City of Kirkland Planning and Building Department 123 5th Avenue, Kirkland, WA 98033 425-587-3600 ~ www.kirklandwa.gov

Development Standards List

File: DRV22-00466

PUBLIC WORKS CONDITIONS Permit #: DRV22-00466 Project Name: Swyft

Figure 1. Subject area requiring tree protection

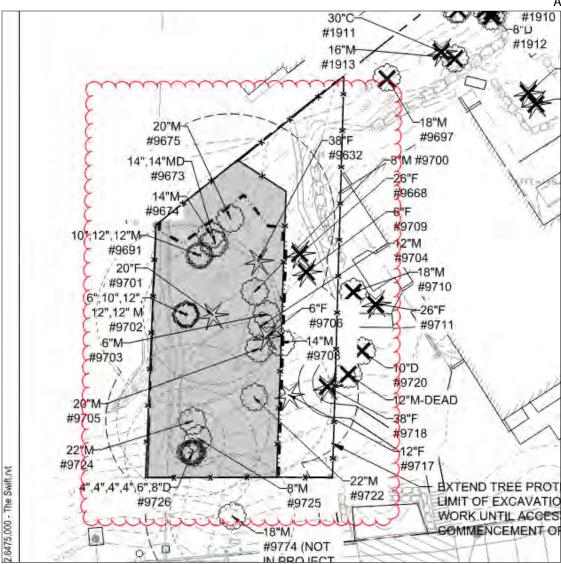
1. Tree Protection Area at the western edge of the site will be impacted by proposed pathway, stairs, and amenities. Tree protection during development shall meet standards of KZC 95.32. Work with project arborist to prepare project-specific specifications for constructing proposed improvements throughout this area. Schedule a site meeting with the City Arborist, Planning Official, and Project Arborist to assess impacts and protection measures. On-site arborist monitoring and non-invasive excavation methods (air) will likely be required throughout the duration of work within this area.

- 2. Proposed hardscapes/improvements in Tree Protection Area shall be assessed to minimize impacts to trees. This may include:
 - a. Adjusting locations based on field truthing of tree locations and impacts
 - b. Utilizing pervious materials and/or options that require less excavation and compaction to install
 - c. Installing root barriers to prevent future root and infrastructure conflicts
